AMERICANS WITH DISABILITY ACT (ADA) FACILITY ASSESSMENT REPORT

Americans with Disabilities Act (ADA) Facility Barrier Report

For Selected Park Sites

July 2024

Nadaka Nature Park

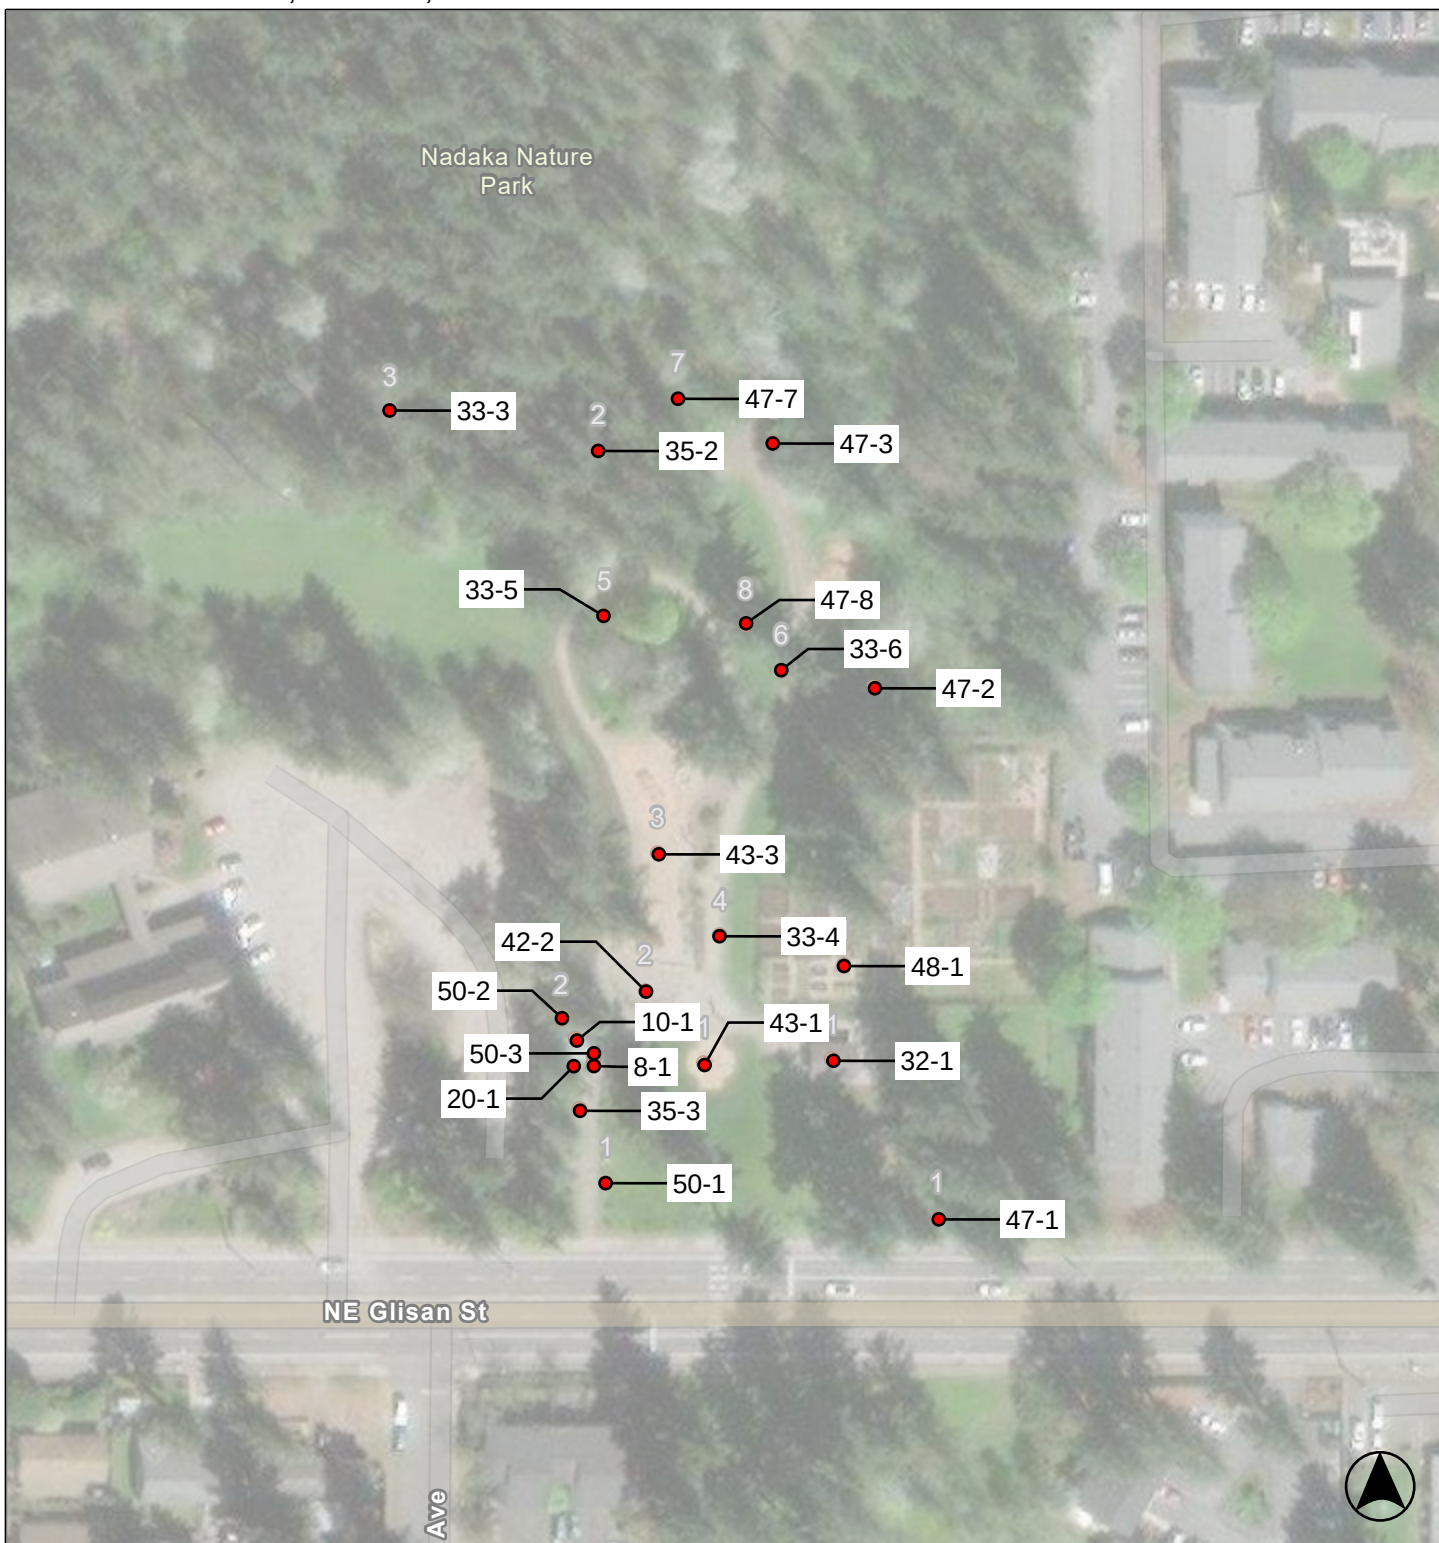
ADA: -		
Other: ABA F245.2.2		
33 - 1	Outdoor Constructed Features	Category: 3
Increase or provide clear floor area		\$200
Notes: A clear ground space is not provided adjacent to the bench (36" by 48" min).		
ADA: -		
Other: ABA 1011.2.1, ABA 1011.2.3

Park		
33 - 2	Outdoor Constructed Features	Category: 3
Increase or provide clear floor area		\$200
Notes: A clear floor space is not provided at the trash container opening (36" by 48" min forward approach).		
ADA: -		
Other: ABA 1011.2		
Provide an accessible route		\$2,560
Notes: An accessible route to the fixed trash/recycling container is not provided. Route is 32 linear feet over grass from to the container. (48" wide minimum path of travel constructed with an accessible surface)		
ADA: -		
Other: ABA F206.2.2		
33 - 3	Outdoor Constructed Features	Category: 3
Increase or provide clear floor area		\$200
Notes: A clear ground space is not provided adjacent to the bench (36" by 48" min).		
ADA: -		
Other: ABA 1011.2.1, ABA 1011.2.3		
Provide an accessible route		\$1,600
Notes: An accessible route to the fixed bench is not provided. Route is 20 linear feet over dirt and grass from route to bench.		
ADA: -

Other: ABA F206.2.2		
33 - 4	Outdoor Constructed Features	Category: 3
Increase or provide clear floor area		\$400
Notes: A clear ground space is not provided adjacent to the bench (36" by 48" min). (x2)		
ADA: -		
Other: ABA 1011.2.1, ABA 1011.2.3		
33 - 5	Outdoor Constructed Features	Category: 3
Provide an accessible route		\$2,000
Notes: An accessible route to the fixed bench is not provided. Route is 25 linear feet over grass to the bench.		
ADA: -		
Other: ABA F206.2.2

Park		
33 - 6	Outdoor Constructed Features	Category: 3
Increase or provide clear floor area		\$200
Notes: A clear floor space is not provided at the trash container opening (36" by 48" min forward approach). Surface is not stable or firm.		
ADA: -		
Other: ABA 1011.2		
35 - 1	Other	Category: 3
Increase or provide maneuvering or clear floor area		\$200
Notes: Clear floor space of the dog bag station is not provided (30" by 48" min).		
ADA: 305.2, 305.3, 305.5		
Other: -		
35 - 2	Other	Category: 3
Increase or provide maneuvering or clear floor area		\$200
Notes: Clear floor space of the dog bag station is not provided (30" by 48" min).		
ADA: 305.2, 305.3, 305.5		
Other: -		
Provide an accessible route		\$1,200
Notes: An accessible path of travel is not provided to the dog bag station. Surface is grass and dirt for 15 linear feet (firm, stable, and slip resistant).		
ADA: 206.2		
Other: -		
35 - 3	Other	Category: 3

Park		
43 - 3	Play Equipment Area	Category: 3
Improve or evaluate play area surface		\$0
Notes: Ground surface in play area is in need of maintenance and further evaluation of fall attenuation surface is recommended.		
ADA: 1008.2.6.1, 1008.2.6.2		
Other: -		
Provide an accessible route		\$160
Notes: Gaps in ramp to play area are 1" wide (1/2" maximum). X2 gaps		
ADA: 1008.2.5.1		
Other: -		
47 - 1	Trails	Category: 3
Provide a firm, stable and slip resistant surface		\$1,480
Notes: The trail surface is not firm and stable. Trail surface is woodchips, dirt, and debris for 37 linear feet.		
ADA: -		
Other: ABA 1017.2		
47 - 2	Trails	Category: 3
Provide a firm, stable and slip resistant surface		\$6,800
Notes: The trail surface is not firm and stable. Trail surface is woodchips, dirt, and debris for 170 linear feet.		
ADA: -		
Other: ABA 1017.2		
47 - 3	Trails	Category: 3
Provide a firm, stable and slip resistant surface		\$8,400

Notes: The trail surface is not firm and stable. Trail surface is woodchips, dirt, and debris for 210 linear feet.		
ADA: -		
Other: ABA 1017.2		
47 - 4	Trails	Category: 3
Provide a firm, stable and slip resistant surface		\$8,600
Notes: The trail surface is not firm and stable. Trail surface is woodchips, dirt, and debris for 215 linear feet.		
ADA: -		
Other: ABA 1017.2

Park		
47 - 5	Trails	Category: 3
Provide a firm, stable and slip resistant surface		\$4,600
Notes: The trail surface is not firm and stable. Trail surface is woodchips, dirt, and debris for 115 linear feet. The run slope at the north park entrance is 11% at the transition to the street.		
ADA: -		
Other: ABA 1017.2		
47 - 6	Trails	Category: 3
Provide a firm, stable and slip resistant surface		\$2,600
Notes: The trail surface is not firm and stable. Trail surface is woodchips, dirt, and debris for 65 linear feet.		
ADA: -		
Other: ABA 1017.2		
47 - 7	Trails	Category: 3
Provide a firm, stable and slip resistant surface		\$5,040
Notes: The trail surface is not firm and stable. Trail surface is woodchips, dirt, and debris for 126 linear feet.		
ADA: -		
Other: ABA 1017.2		
47 - 8	Trails	Category: 3
Provide a firm, stable and slip resistant surface		\$1,760
Notes: The trail surface is not firm and stable. Trail surface is woodchips, dirt, and debris for 44 linear feet.

ADA: -		
Other: ABA 1017.2		
48 - 1	Equivalent Facilitation Consideration	Category: 1
EQUIVALENT FACILITATION CONSIDERATION		\$0
Notes: Provide route through the community garden with a stable and firm surface that is 48" wide and clear. Current surface is woodchips.		
ADA: -		
Other: -		
50 - 1	Universal Design Recommendations	Category: 5
Increase or provide clear space		\$0
Notes: Provide a clear floor space for approach to the informational sign. Consider providing a larger text size, tactile information, and/or audio options for visitors with visual disabilities.		
ADA: -		
Other: -

Park		
50 - 2	Universal Design Recommendations	Category: 5
Increase or provide clear space		\$0
Notes: Provide a clear floor space for approach to the informational sign. Consider providing a larger text size, tactile information, and/or audio options for visitors with visual disabilities.		
ADA: -		
Other: -		
50 - 3	Universal Design Recommendations	Category: 5
Increase or provide clear space		\$0
Notes: Shelter reservation list/bulletin board may not be legible to a person with visual disabilities. Consider providing a larger text size, tactile information, and/or audio options for visitors with visual disabilities. A QR code to the reservations webpage, such as the one at Red Sunset Park, may be a good option.		
ADA: -		
Other: -

North Gresham Park

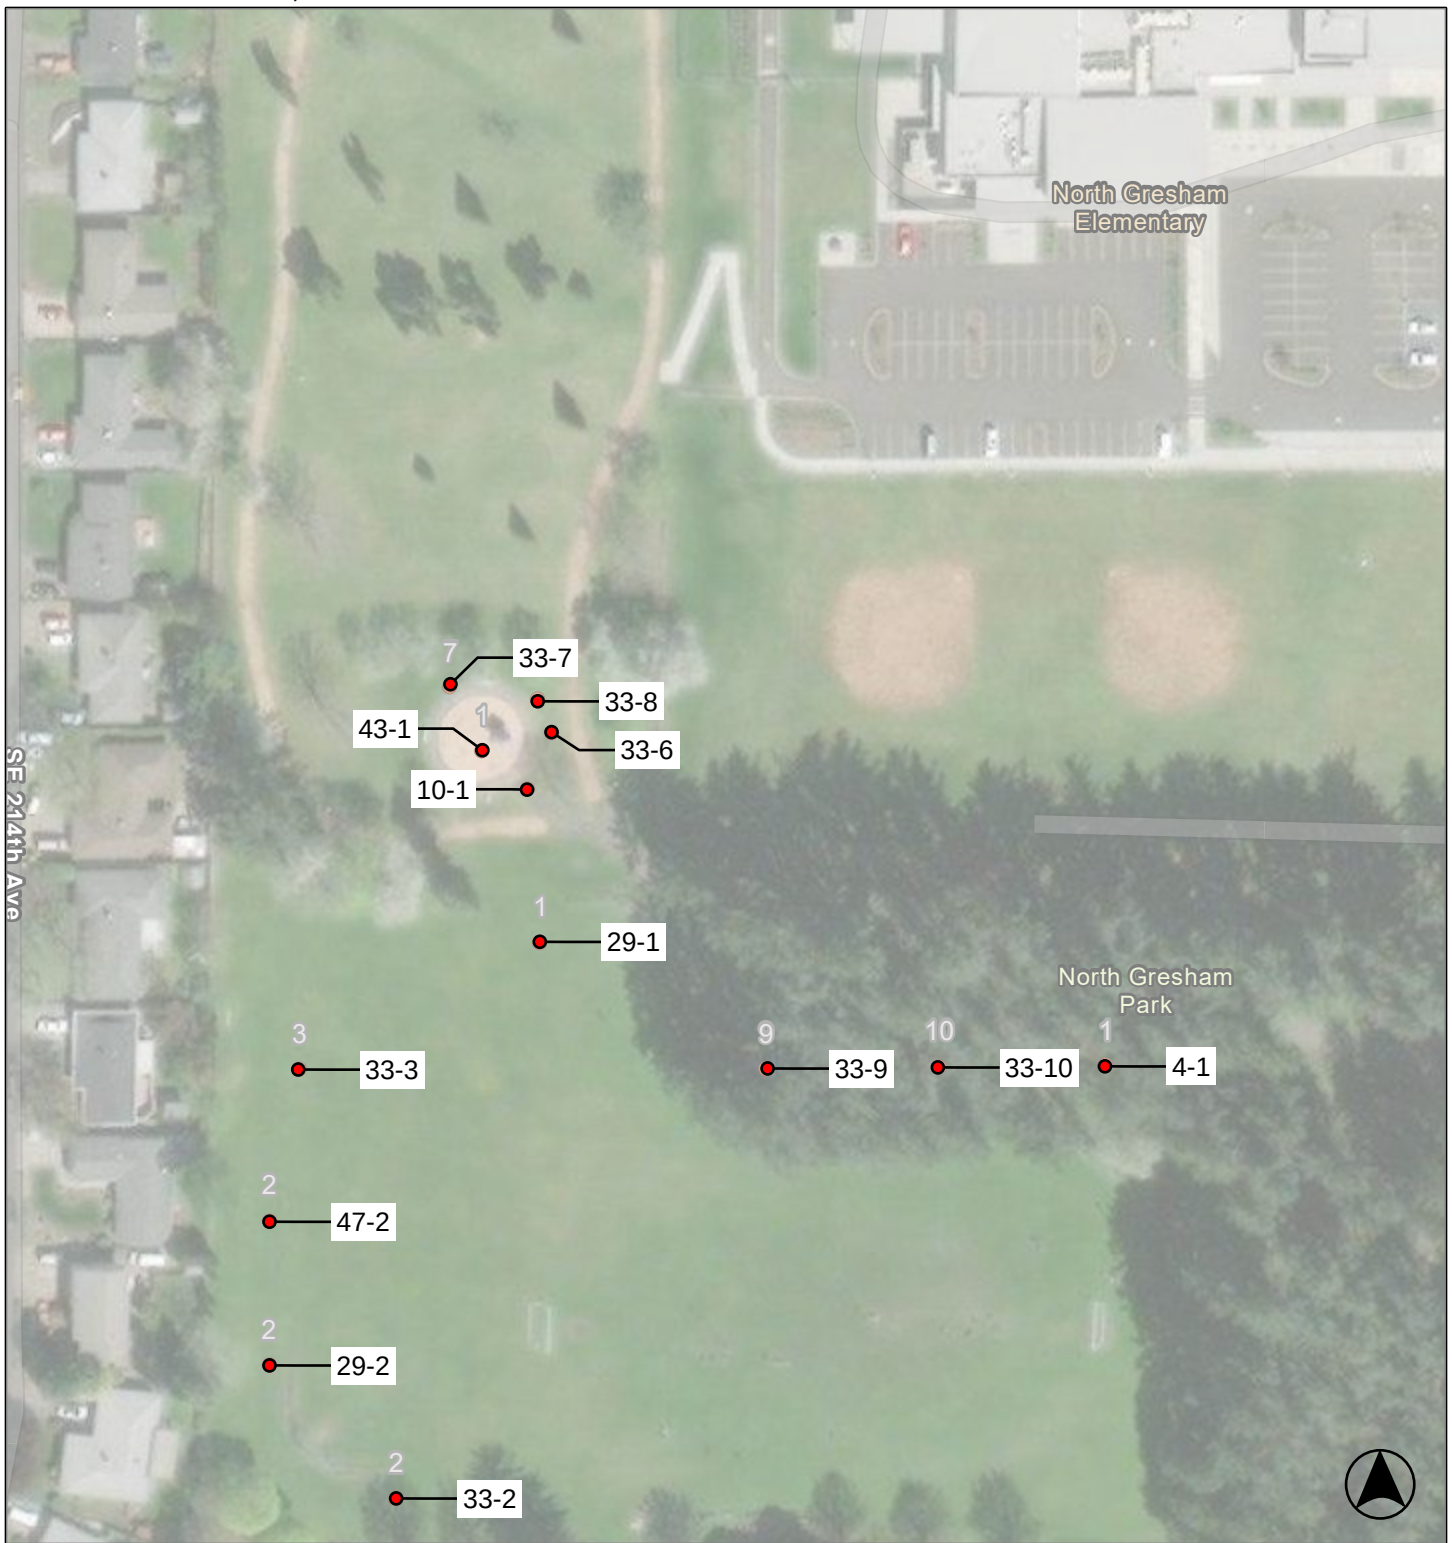
Park		
4 - 1	Walk	Category: 1
Provide an accessible route		\$55,600
Notes: An accessible route is not provided due to grass for 695 linear feet.		
ADA: 206.2.2		
Other: -		
4 - 2	Walk	Category: 1
Provide an accessible route		\$31,440
Notes: An accessible route is not provided from SE Salmon St. to the backstop for 393 linear feet.		
ADA: 206.2.2		
Other: -		
10 - 1	Drinking Fountain	Category: 3
Confirm water flow compliance		\$0
Notes: Water service to the drinking fountain was disconnected at the time of the assessment. Flow height and angle could not be confirmed.		
ADA: 602.3, 602.6		
Other: -		
29 - 1	Game and Sports Area	Category: 2
Provide wheelchair seating		\$3,600
Notes: No wheelchair spaces provided in team seating areas (two min - one per team space).		
ADA: 221.2.1.4		
Other: -		
Provide an accessible route		\$800
Notes: An accessible route to the baseball area is not provided. Route from path to the backstop is 10 linear feet over grass.

ADA: 206.2.2		
Other: -		
29 - 2	Game and Sports Area	Category: 2
Provide wheelchair seating		\$3,600
Notes: No wheelchair spaces provided in team seating areas (two min - one per team space). (x2)		
ADA: 221.2.1.4		
Other: -

Park		
33 - 1	Outdoor Constructed Features	Category: 3
Increase or provide clear floor area		\$200
Notes: A clear ground space is not provided adjacent to the bench (36" by 48" min).		
ADA: -		
Other: ABA 1011.2.1, ABA 1011.2.3		
33 - 2	Outdoor Constructed Features	Category: 3
Increase or provide clear floor area		\$200
Notes: A clear ground space is not provided adjacent to the bench (36" by 48" min).		
ADA: -		
Other: ABA 1011.2.1, ABA 1011.2.3		
33 - 3	Outdoor Constructed Features	Category: 3
Increase or provide clear floor area		\$200
Notes: A clear ground space is not provided adjacent to the bench (36" by 48" min).		
ADA: -		
Other: ABA 1011.2.1, ABA 1011.2.3		
33 - 4	Outdoor Constructed Features	Category: 3
Increase or provide clear floor area		\$200
Notes: A clear ground space is not provided adjacent to the bench (36" by 48" min).		
ADA: -		
Other: ABA 1011.2.1, ABA 1011.2.3		
33 - 5	Outdoor Constructed Features	Category: 3

Increase or provide clear floor area		\$200
Notes: A clear ground space is not provided adjacent to the bench (36" by 48" min).		
ADA: -		
Other: ABA 1011.2.1, ABA 1011.2.3		
33 - 6	Outdoor Constructed Features	Category: 3
Increase or provide clear floor area		\$200
Notes: A clear ground space is not provided adjacent to the bench (36" by 48" min).		
ADA: -		
Other: ABA 1011.2.1, ABA 1011.2.3		
33 - 7	Outdoor Constructed Features	Category: 3
Increase or provide clear floor area		\$200
Notes: A clear ground space is not provided adjacent to the bench (36" by 48" min).		
ADA: -		
Other: ABA 1011.2.1, ABA 1011.2.3

Park		
33 - 8	Outdoor Constructed Features	Category: 3
Increase or provide clear floor area		\$200
Notes: A clear ground space is not provided adjacent to the bench (36" by 48" min).		
ADA: -		
Other: ABA 1011.2.1, ABA 1011.2.3		
33 - 9	Outdoor Constructed Features	Category: 3
Increase or provide clear floor area		\$200
Notes: A clear ground space is not provided adjacent to the bench (36" by 48" min).		
ADA: -		
Other: ABA 1011.2.1, ABA 1011.2.3		
33 - 10	Outdoor Constructed Features	Category: 3
Increase or provide clear floor area		\$200
Notes: A clear ground space is not provided adjacent to the bench (36" by 48" min).		
ADA: -		
Other: ABA 1011.2.1, ABA 1011.2.3		
43 - 1	Play Equipment Area	Category: 2
Improve or evaluate play area surface		\$0
Notes: Ground surface in play area is in need of maintenance and further evaluation of fall attenuation surface is recommended.		
ADA: 1008.2.6.1, 1008.2.6.2		
Other: -

Regrade or replace ramp		\$540
Notes: The ramp into the play area has a 10% slope (8.33% max).		
ADA: 240.2.1		
Other: -		
47 - 1	Trails	Category: 2
Provide a firm, stable and slip resistant surface		\$80,720
Notes: The trail surface is not firm and stable. Trail surface is loose woodchips for 2018 linear feet.		
ADA: -		
Other: ABA 1017.2		
Install sign		\$250
Notes: A trail sign is not provided.		
ADA: -		
Other: ABA 1017.10

Park	
47 - 2	Trails
Category: 2	
Provide a firm, stable and slip resistant surface	
\$15,520	
Notes: The trail surface is not firm and stable. Trail surface is grass and dirt for 388 linear feet.	
ADA: -	
Other: ABA 1017.2	
Install sign	
\$250	
Notes: A trail sign is not provided.	
ADA: -	
Other: ABA 1017.10	
47 - 3	Trails
Category: 2	
Provide a firm, stable and slip resistant surface	
\$26,880	
Notes: The trail surface is not firm and stable. Trail surface is grass and dirt for 672 linear feet. Trail is implied along the South edge of filed with benches, connects to adjacent right-of-way.	
ADA: -	
Other: ABA 1017.2	
Install sign	
\$250	
Notes: A trail sign is not provided.	
ADA: -	
Other: ABA 1017.10
